[Upgrade to revision]

R20TS0328EJ0100

Programming GUI "FP6 Terminal"

for the PG-FP6 Flash Memory Programmer V1.02.00

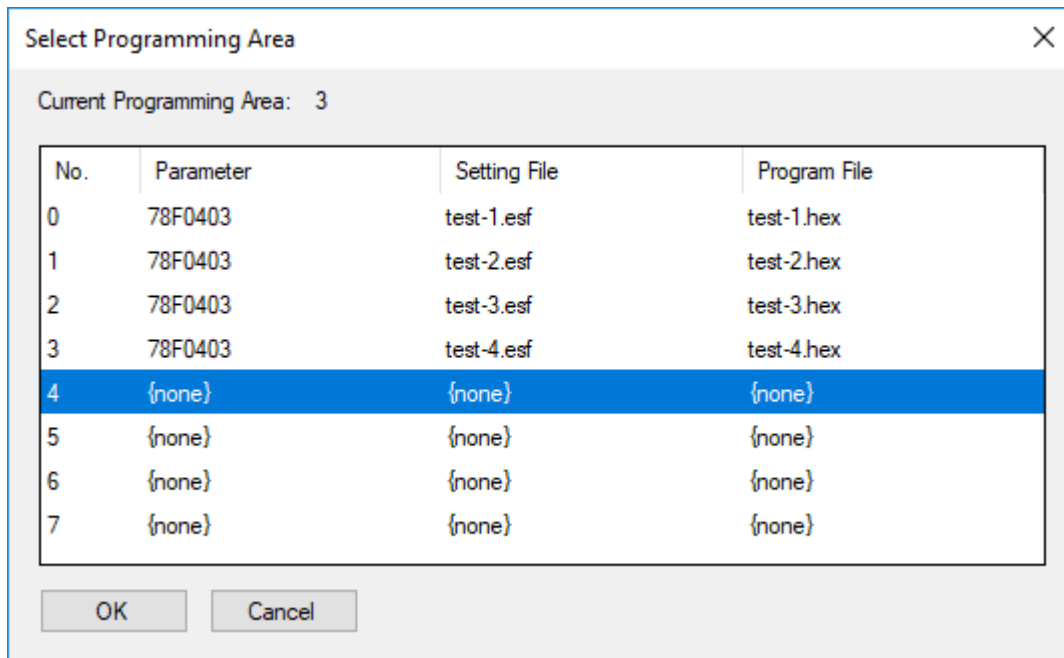
(2) Addition of area specification to the Fill with 0xFF function

Applicable MCUs: RH850 family, RX64M group, RX651 group, RX65N group, RX71M group, and Renesas Synergy microcontrollers

Selection options [Code Flash / User Boot] and [Data Flash] are to be added to [Fill with 0xFF] on the [Operation Settings] tab. This allows the Fill with 0xFF function to be specified for each area.

(5) Addition of the target MCU search function

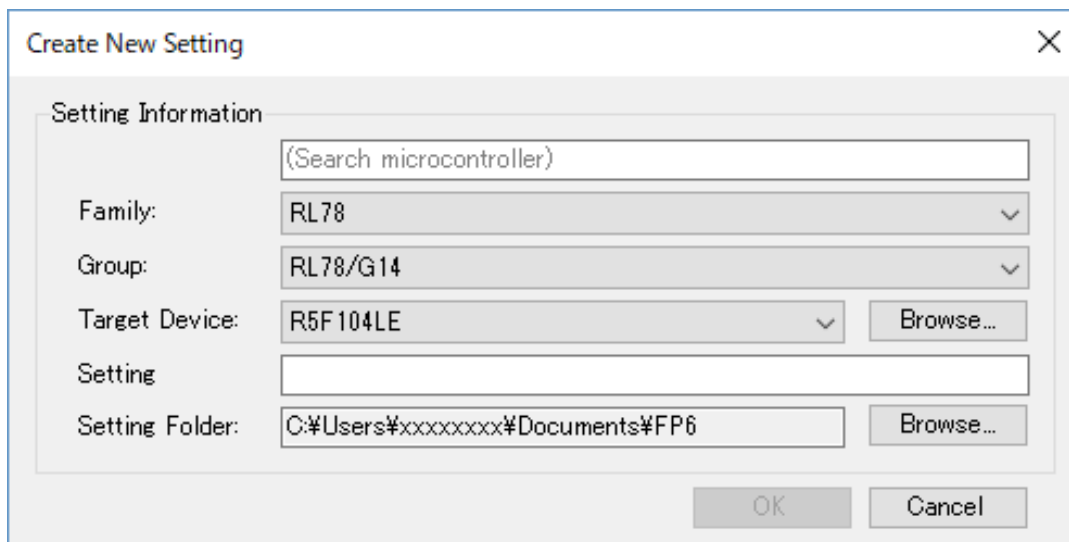
You can use the [Create New Setting] dialog box to search for the target MCU.
